BUTLER COUNTY BLDG. DEPT.

ADDENDUM 1.4

JOB NO: 212-15-0411

TK CONSTRUCTORS
NEW ORLEANS

FLOOR PLAN

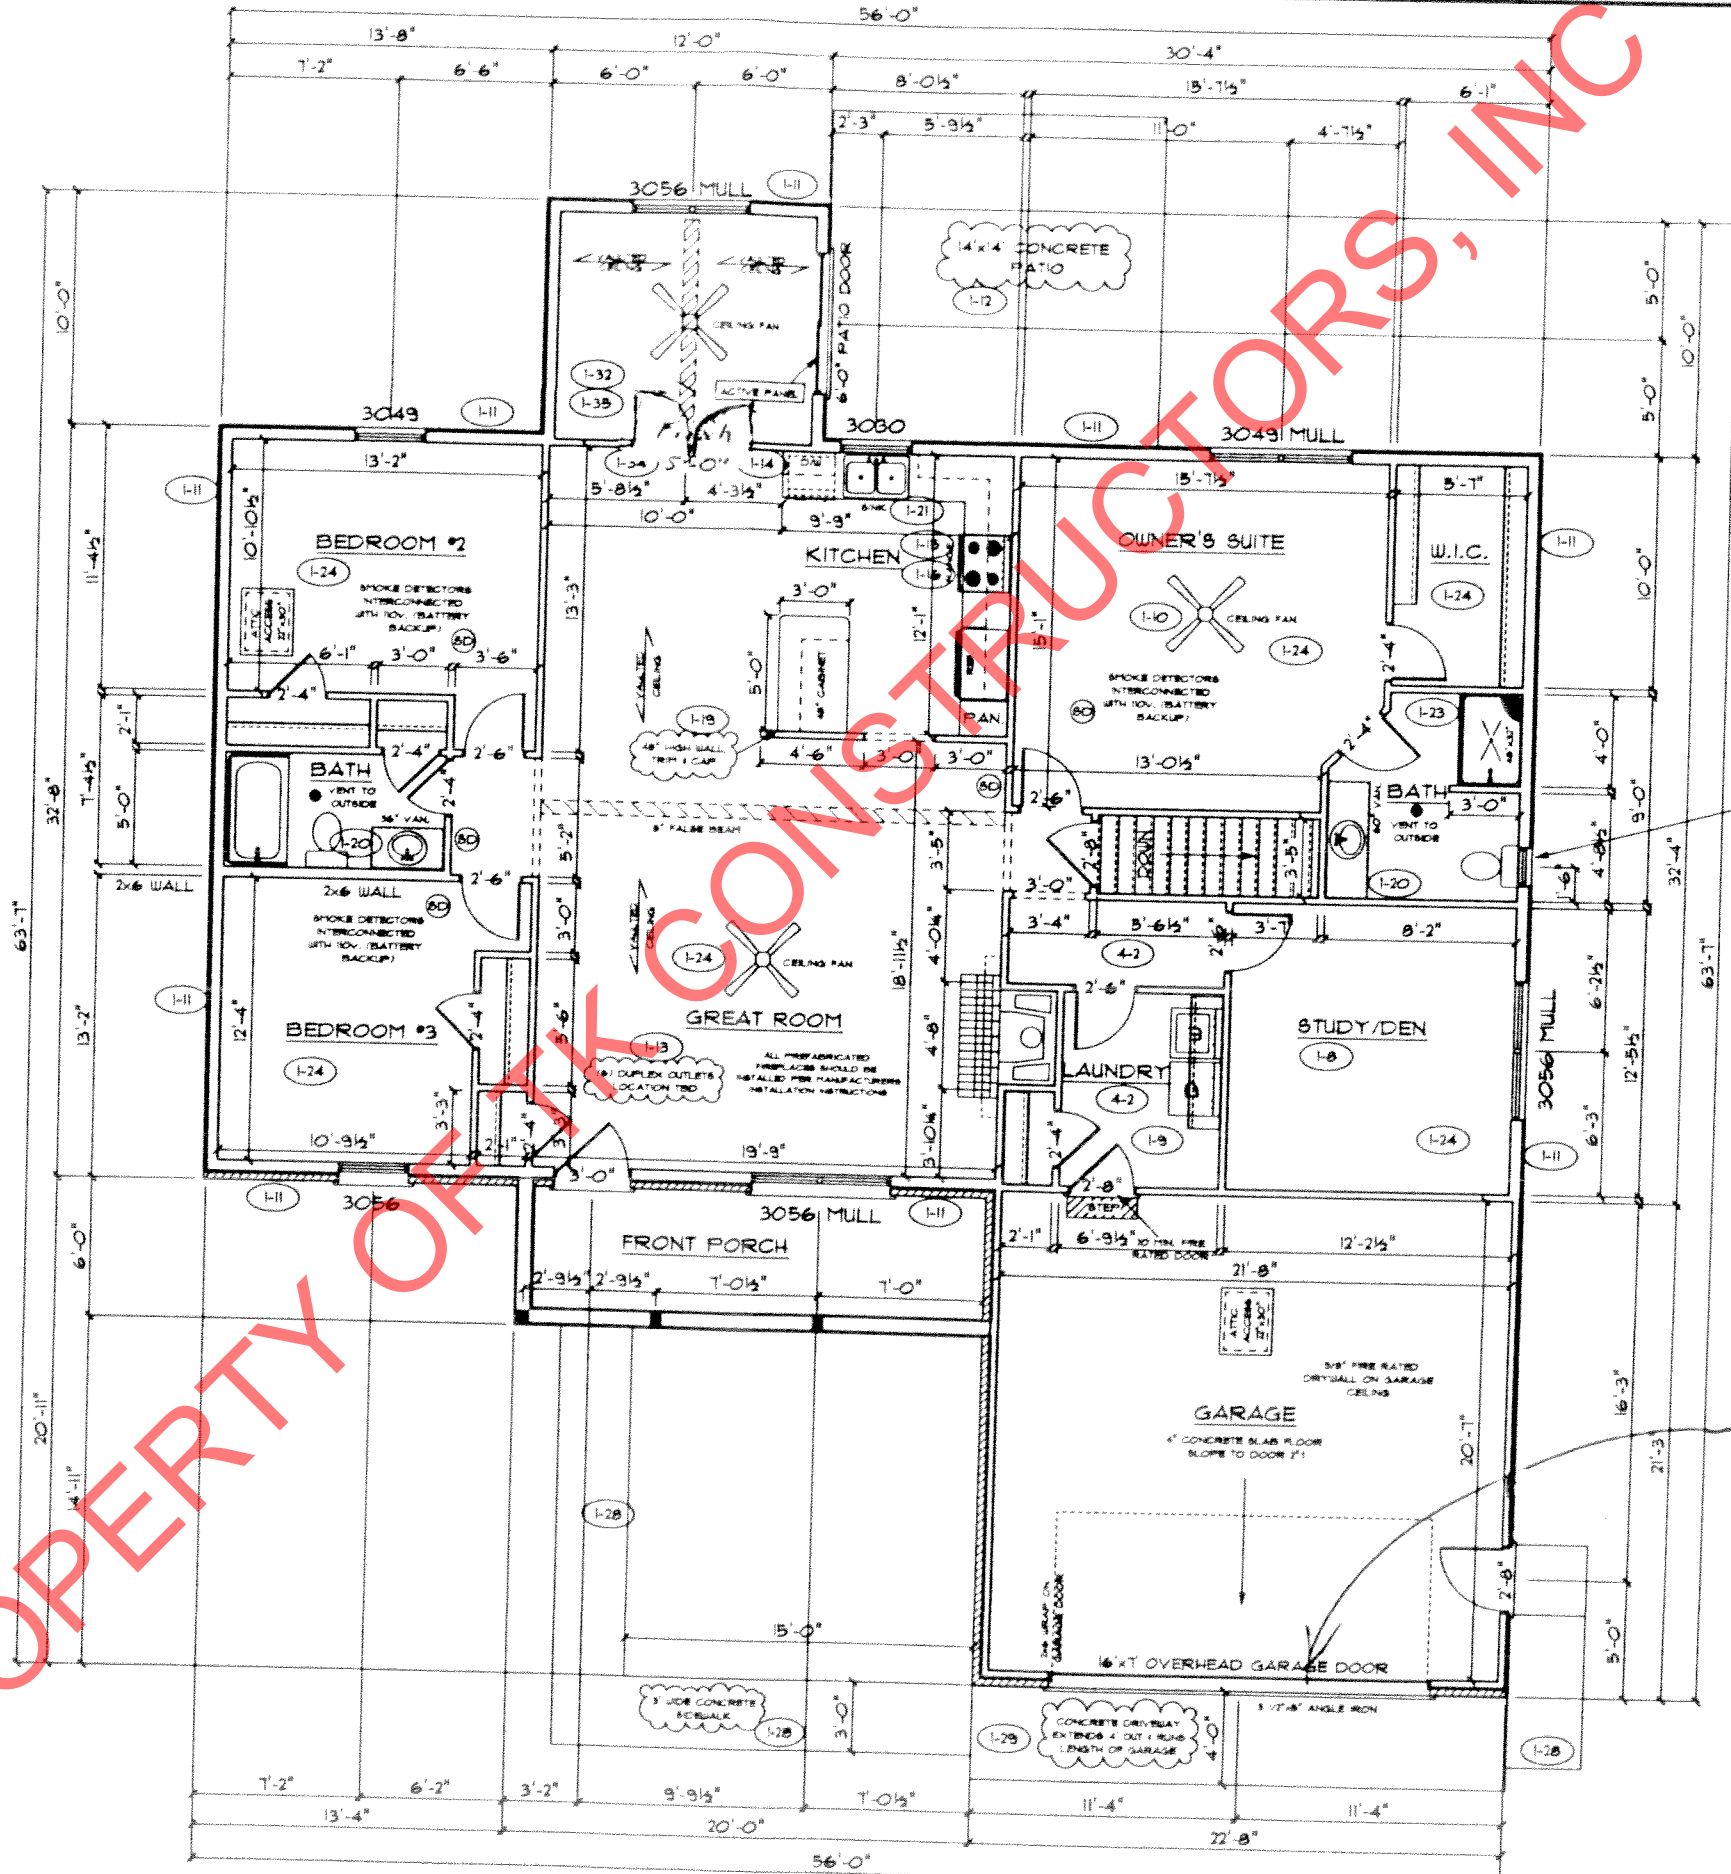
Garage header & Lintel to be designed/sized by lumber company to handle LL+DL w/ L/600 deflection
